RE: Nitsch Project #9419
Commonwealth Fusion (CFS-3)
125 Hospital Road
Site Plan and Stormwater Review
Devens, MA

Nitsch is providing comments with respect to Site Plan and Stormwater Management in this letter. Please note that traffic and landscape review are being provided in separate letters.

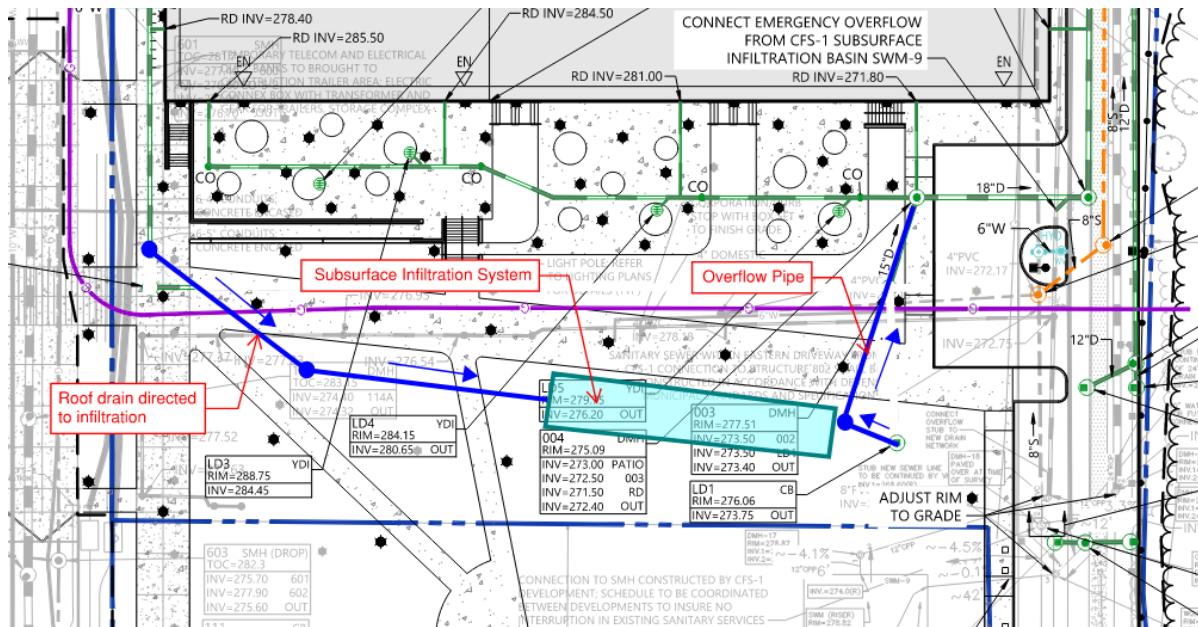
5. **974 CMR 3.04(3)(a)(2.f)(v)** requires that Low Impact Development (LID) techniques shall be incorporated in accordance with 974 CMR 4.08 to the maximum extent feasible. The Applicant should consider incorporating additional LID techniques. Possible techniques include, but are not limited to, the construction of new walkways, the terraced plaza, and parking stalls with permeable materials, including porous asphalt or porous pavers. See Comments 7, 21, and 31.

- 1. Pervious paving materials are not practical on a site when the vast majority of pavement is subject to truck traffic. While there are small stretches of single-aisle parking areas, we have long-term viability concerns about having an abrupt change in material/pavement section directly abutting the heavy magnet transport route.**
- 2. Porous pavement is an expensive redundancy – the design already puts all collected storm water in the ground such that there are no surface water discharges, and adding these features does not further reduce stormwater runoff nor provide environmental benefits lacking from the proposed design.**

VHB Response (12/05/2025): Permeable pavers and pavement is not suitable for this site; however, alternative methods of LID and water management will be explored, including collection water in tree wells and implementation of raingardens.

Regarding sidewalks: the majority of sidewalks on the site are located in the campus green. While not accounted for in this way in the stormwater report, these sidewalks are “disconnected” impervious areas that would qualify for LID Design Credit 3 per the Massachusetts Stormwater Handbook.

Also please recognize that the 600-space parking garage itself is an example of low-impact design. Parking garages are a compact alternative to sprawling surface lots that come with associated stormwater runoff, pollution, and heat-island impacts.

Drainage Emergency Shutoff Valve

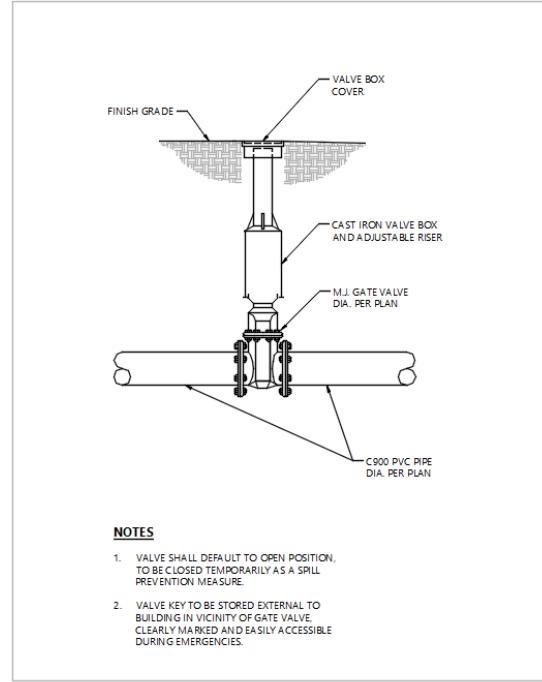
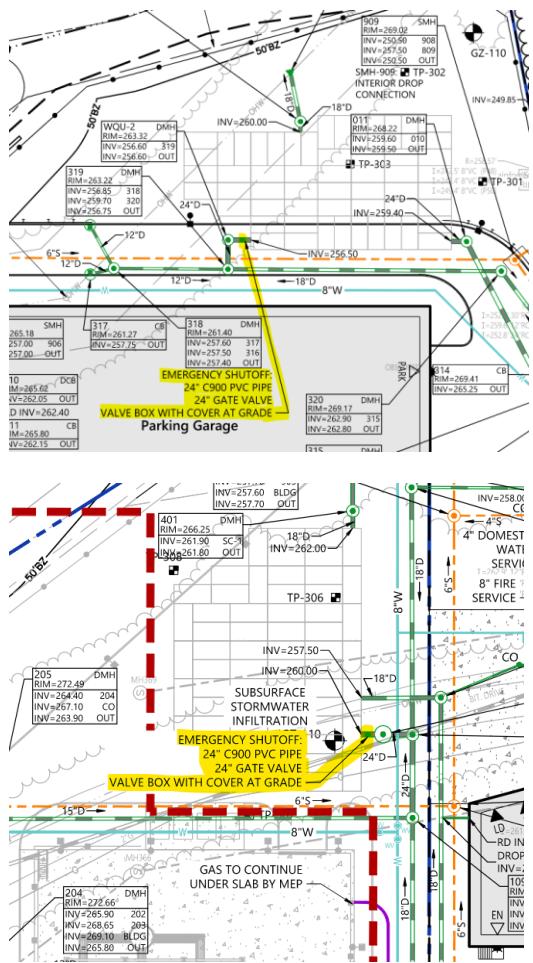
27. **974 CMR 3.04(4)(b)(4)** decrees that catch basins or other drainage features in loading/unloading and/or fueling areas shall be equipped with post-indicator valves (which are to remain in the closed position) on the outlets for containment in the event of any spills. The Applicant should add post-indicator valves to DMH-319 or WQU-2; DMH-604; and DMH-113 or WQU-1 in order to isolate any potential spills prior to infiltration.

Nitsch Response (12/18/2025): Nitsch agrees that post-indicator valves should default to the “open” position to manage precipitation events. Nitsch recommends notes are added to downstream manholes equipped with emergency shut off valves, and relevant details are added to Sheet C6.02.

VHB Response (12/05/2025): This site does not contain any outdoor vehicle fueling areas, only typical recessed warehouse loading docks. The term “post indicator valve” implies that the valve’s state of “open” or “closed” needs to be visible from the surface, while the requirement that the valve defaults to the “closed” position creates great risk during precipitation events—especially when located in the main drainage trunk line (such as with the above-suggested manholes). VHB understands the desire for an emergency shut off valve to protect the subsurface infiltration basin from spills, which can be provided in a downstream manhole, defaulting to the open position, to be closed in the event of a spill. We trust this meets the intent of this regulation.

VHB Response (1/16/2026): There are symbols and notes present on Sheet C5.01 that indicate the location and nature of the spill prevention valves. Additionally, a detail has been added to Sheet C6.02. Screenshots of the notes and details are shown below:

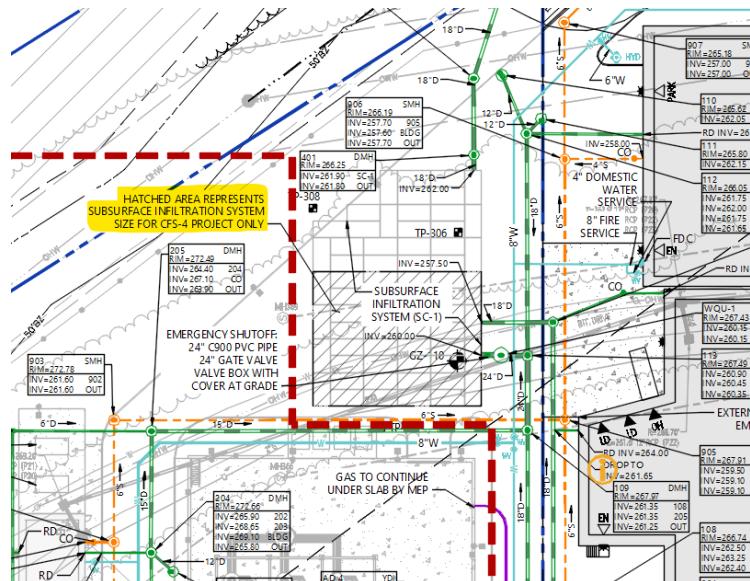
40. We note that SC-1 appears to be an addition to the subsurface infiltration system proposed with the CFS-4 development. The Applicant should provide additional information on the construction phasing to clarify the planned construction sequence of the addition to SC-1.

Nitsch Response (12/18/2025): Nitsch recommends a note is added to the CFS-3 plans to indicate the extent of the proposed subsurface infiltration system intended to treat the CFS-4 area.

VHB Response (12/05/2025): It is more accurate to say the SC-1 “expands upon” the subsurface infiltration basin proposed with the CFS-4 development (rather than being “in addition to”). Another way to look at it would be to say that SC-1, as shown in the CFS-3 plans, is the “full build out” of the basin required to support both CFS-3 and CFS-4 in tandem. The smaller version of the basin shown on the CFS-4 plans represents the minimum basin size needed to support the CFS-4 project only, while the basin shown on the CFS-3 plans depicts what is needed to support both projects at once.

VHB Response (1/16/2026): Clarifying notes have been added to the Site Plans. See screenshot below for an example:
